#### **ADDENDUM NO. 2**

RE: Item #8, October 1, 2025 Letting - NH 0044(227)40, PCN 08D9, Pennington County - Rockfall Hazard Mitigation

DOT PROJECT SECTION NH 0044(227)40 B12

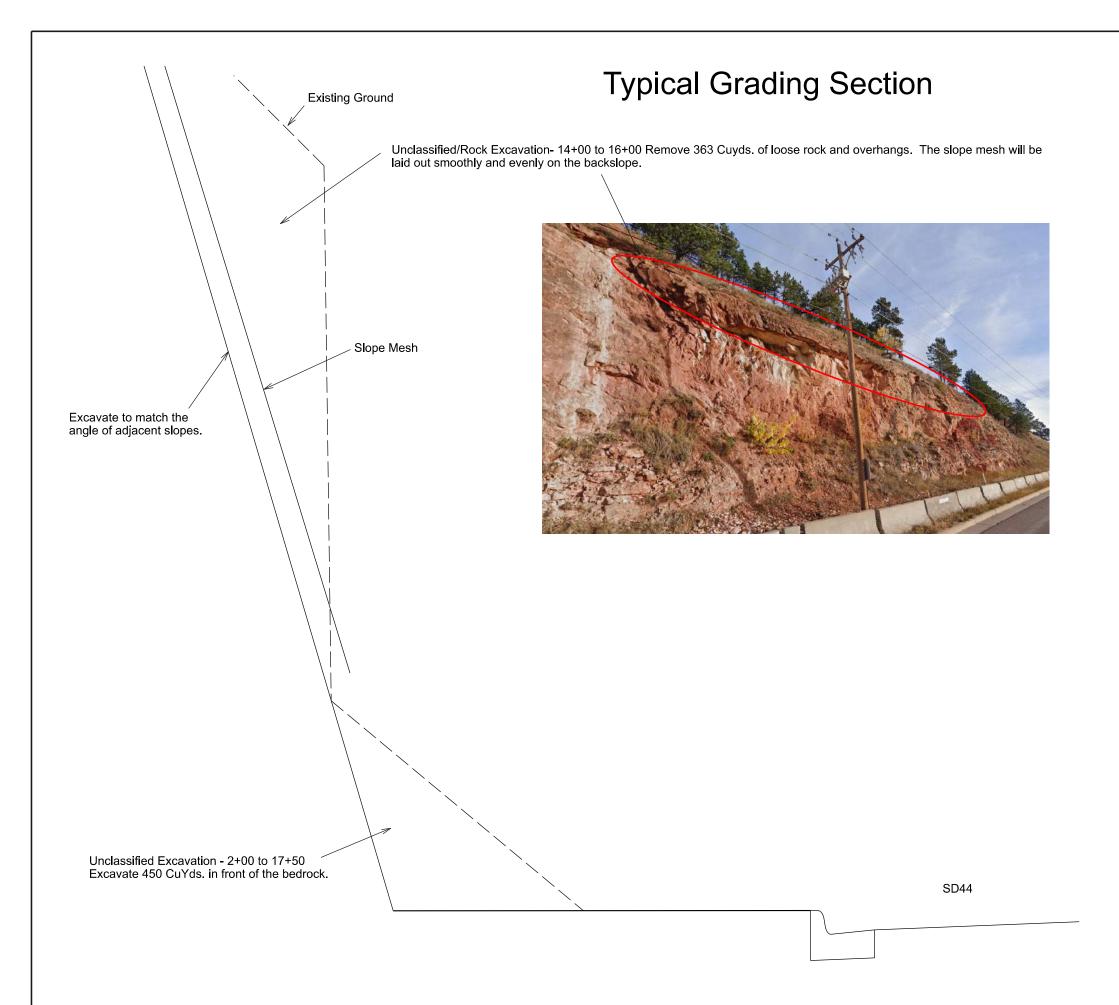
**Sheet B12:** Unclassified Excavation note was revised.
